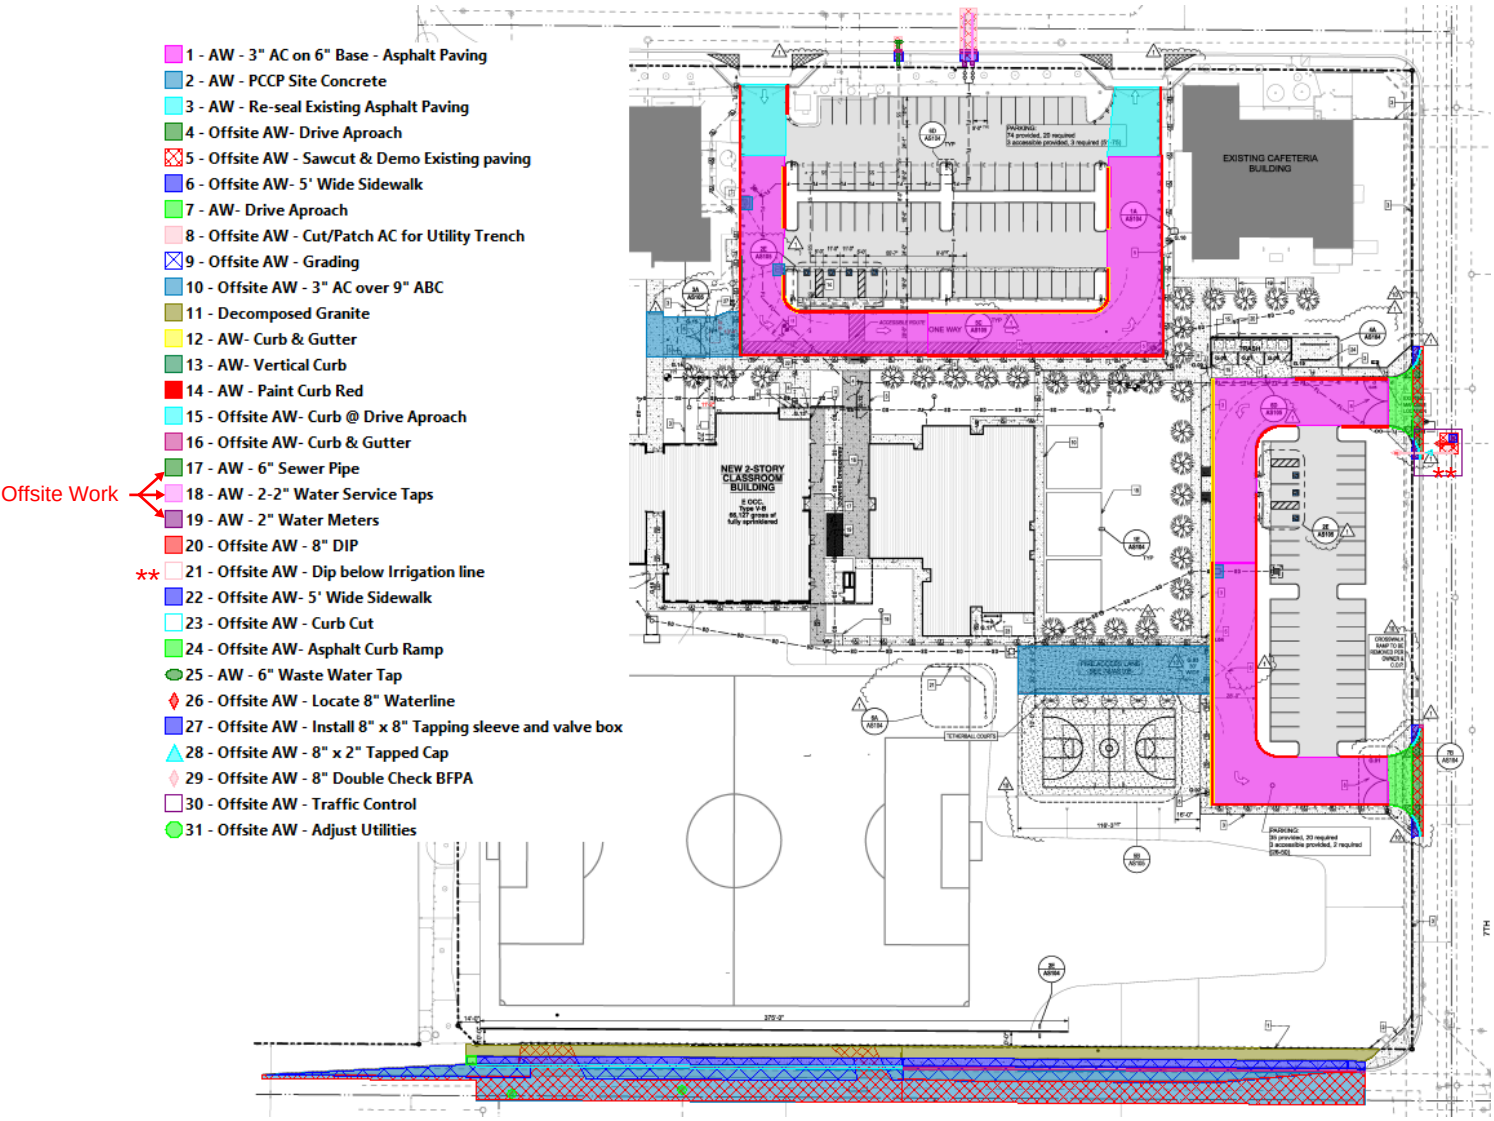
** Line 21 clarification: A Back Tap is required to have the valve installed out of the sidewalk, curb, and gutter area. There is not enough separation between existing waterline and irrigation line to DIP new tap per COP Standard Detail P1370. Cannot depict by drawing
